SERVICE BULLETIN Amateur Radio Group

SUBJECT TM-732A 2Meter Transmit Interference on 70 CM DATE

May 20, 1992

430 MHz TX/RX Unit (X57-4000-XX) Foil Side View

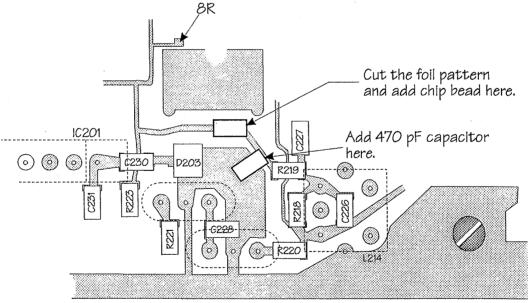
Reports of 70 cm receiver interference might occur when transmission is attempted on This is caused by a harmonic relationship that occurs between some 2 two meters. meter frequencies and the IF image frequency. The resulting signal enters IC201 (FM HIC) on the 8R line of the 430 MHz TX/RX Unit.

Addition of a chip bead and bypass capacitor on the 8R line will correct this tendency.

470 pF chip capacitor

CK73FB1H471K

Chip bead

L92-0131-05

Note: Don't confuse the chip capacitor with the chip bead. They have the same shape. The chip bead is black and the chip capacitor is brown so it should be a simple matter to identify the correct part.
